SAN CARLOS PAVING PROJECT

PROJECT No. 5BCF5032-2C2400051

ADDENDUM NO. 1

Date Issued: August 8, 2013

C12.1

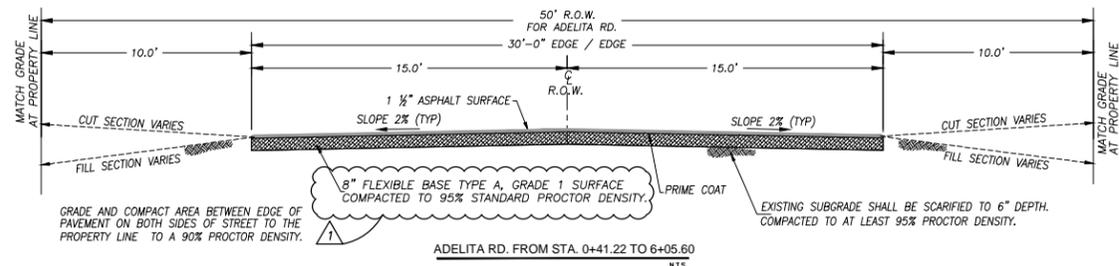
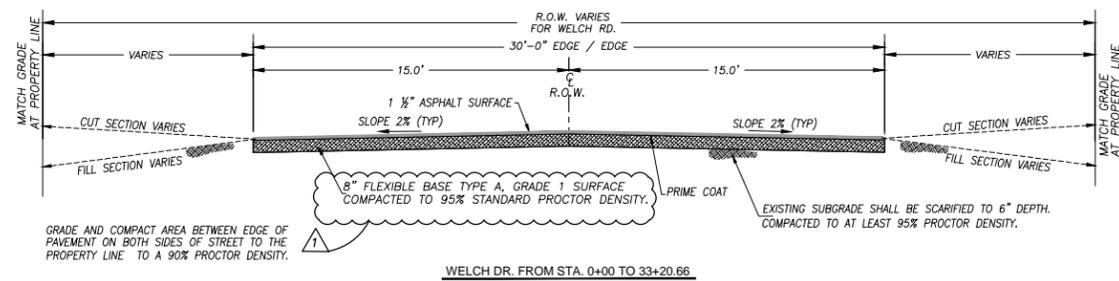
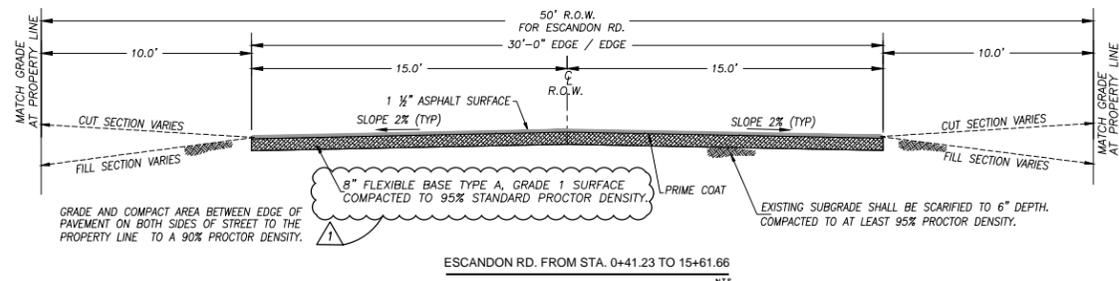
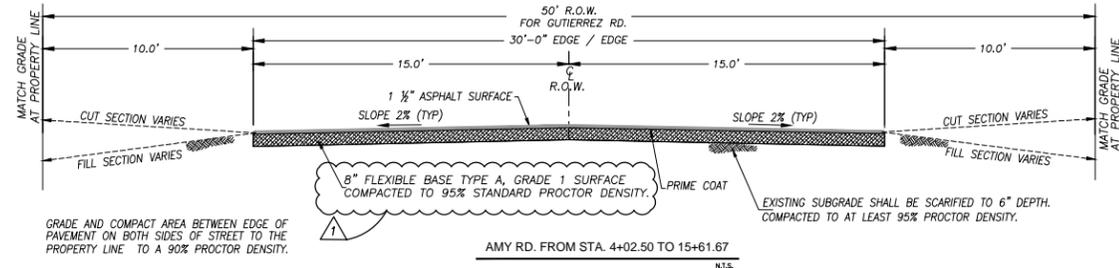
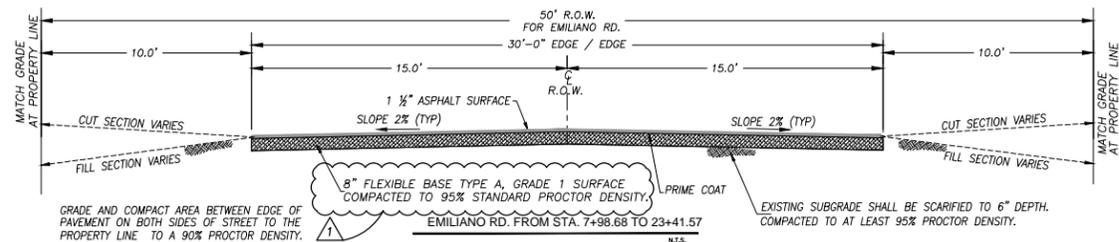
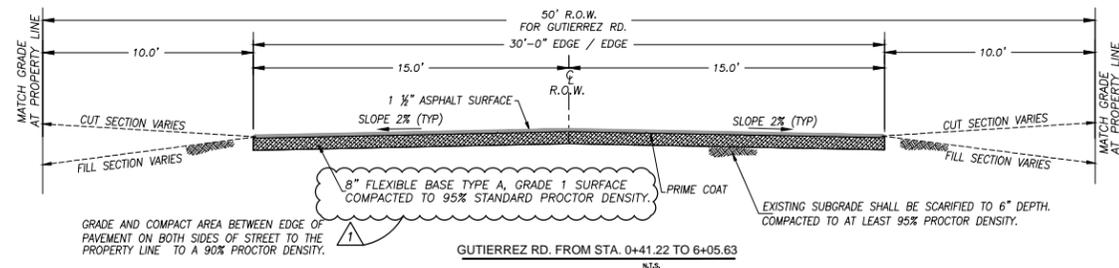
Delete:

Sheet C12 Street Typical Sections

Add:

Sheet C12.1 Street Typical Sections. Attached

Revision	Date	Description
1	08-08-13	ADDENDUM No. 1 TYPE A GRADE 1, FLEX BASE SPECIFIED

The contractor will use Type A, Grade 1.
